UNITED STATES
NUCLEAR REGULATORY COMMISSION
WASHINGTON, D. C. 20555

APPLICANT: Consumers Power Company
FACILITY: Midland Plant, Units 1 and 2
SUBJECT: SUMMARY OF FEBRUARY 2-5, 1982 MEETING AND AUDIT ON AUXILIARY
BUILDING UNDERPINNING

Enclosure 1 is a summary of this meeting and audit.

The first three columns of Enclosure 2 provide a listing of review issues that were to be audited and were provided by the NRC staff at the start of the audit. The last column of Enclosure 2 was added after the audit and indicates the resolutions reached during the audit on the identified review issues.

DIESEL GENERATOR BUILDING EXECUTIVE SUMMARY
SUMMARY OF ACTUAL AND ESTIMATED SETTLEMENTS
FIGURE ES-14

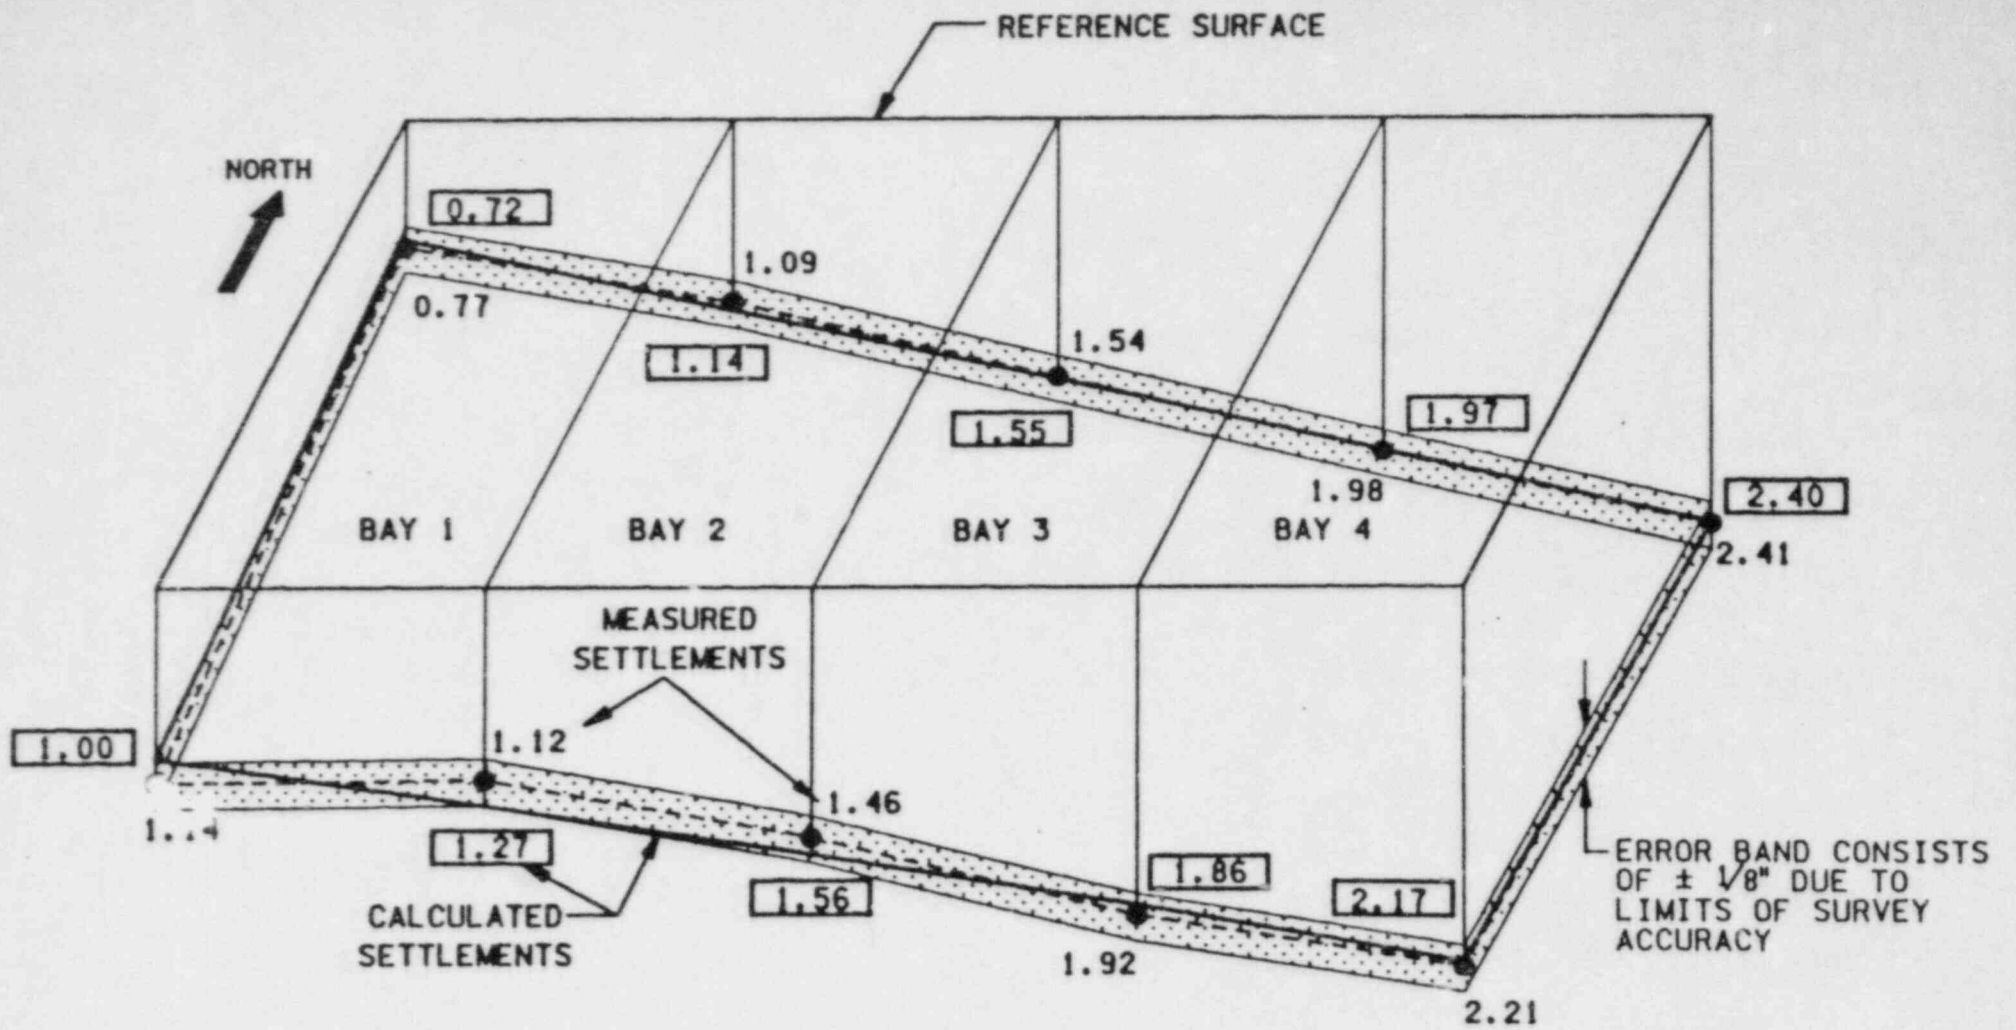
3. Inconsistencies in the documentation of the settlement history needs to be resolved. For example, the Midland Units 1 and 2 Executive Summary dated August, 1983 states that for the July 1978 period, the maximum settlements recorded were 3.5 inches while Figure ES-14 of the same document indicates a maximum of 1.99 inches for the same period.
